Response to Public Consultation – Framework for Infrastructure Development and Sharing

2.1. In-Building Telecommunications Infrastructure Standard

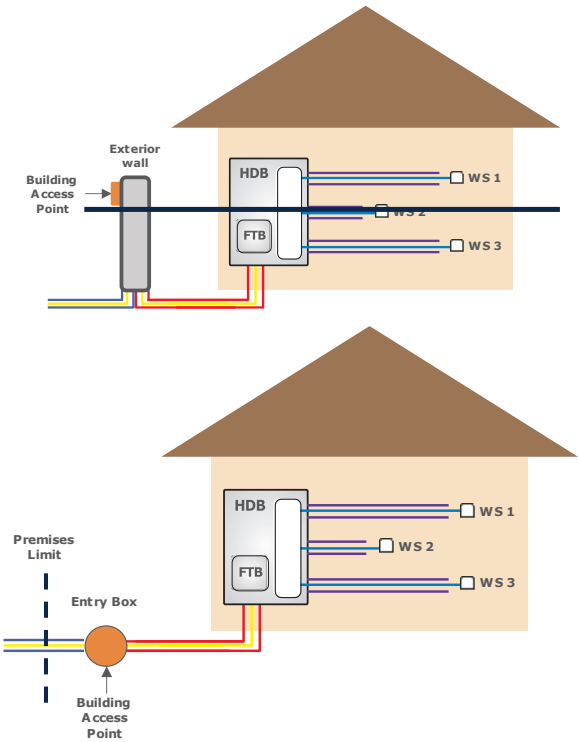
Ooredoo	<p>The use of an outer wall box as stated in 2nd paragraph “It could range from a basic wall box on a single dwelling units (SDU) outer wall to a designated area...” is not suitable for the situation in Qatar.</p> <p>Such solution has been implemented in West-Bay Area more than 20 years back and proved to be a technical failure due to extreme weather conditions here in Qatar during summertime. The key issue was the deterioration of the cable sheath material of drop cables from the outer box to the HDB, which causes repetitive faults and degraded QoS.</p> <p>The lessons learnt from that experience lead to the conclusion that telecommunication passive components (cables, joint boxes, termination points, fiber splices, patch panels, etc.) shall not to be exposed to external weather, and hence since then all externally exposed passive telecom components have been replaced by underground components. Remaining areas are under the process of migration to underground infrastructure. Limitations are in building readiness, not from service providers.</p> <p>Proposed amendments:</p> <p>All telecommunication passive components (cables, joint boxes, termination points, fiber splices, patch panels, etc.) shall be installed using underground technologies only. Passive Telecom components are not allowed to be exposed to external weather. Exterior wall outer box to be removed from 5.2.1, Figure 5.1, and 6.3.1.</p>	<p>Based on the information provided by Ooredoo, the CRA agrees to modify the Building Access Points of the SDUs to be installed underground rather than on the exterior walls of the premises.</p> <p>Updated section 5.2.1 reads as follows:</p> <p><i>“In any development, whether it involves villas, (...).</i></p> <p><i>The type of Building Access Point required shall be located underground, regardless of the development’s characteristics will depend on the development’s characteristics, such as its size, type, structure, and utilization. It could range from a basic wall box on a single dwelling unit’s (SDU) outer wall to a designated area (e.g., exterior manholes) for a larger development. Depending on the development’s needs, multiple access points may be required. Factors such as building size, shape, total number of users, and building utilization shall be considered. This is further described in section 5.3.</i></p> <p><i>(...)”</i></p> <p>Figures 5.1 and 6.2 are amended as follows:</p>

Section	Amendment / New clause
5.3 - Figure 5.1 & 6.3.1 – Figure 6.1	
6.3.1 Detached SDUs	<i>Even though other configurations are possible, the figure below shows a typical case of a single tenant in-building infrastructure, with the Building Access Point located at the exterior wall of <u>entry box within the premise limit</u>.</i>
Table 6.1	<i>Building Access Point: Entry box placed on exterior wall <u>within the premise limit</u>.</i>
Table 6.6	<ul style="list-style-type: none"> - Building of RTTR and MSTR and related EM and civil requirements* - Fiber optic cables supply, pulling, termination, testing and maintenance from the MTR/HDB to i) The FAP; ii) each <u>Secondary Telecommunications Room MSTR</u>, and iii) RTTR
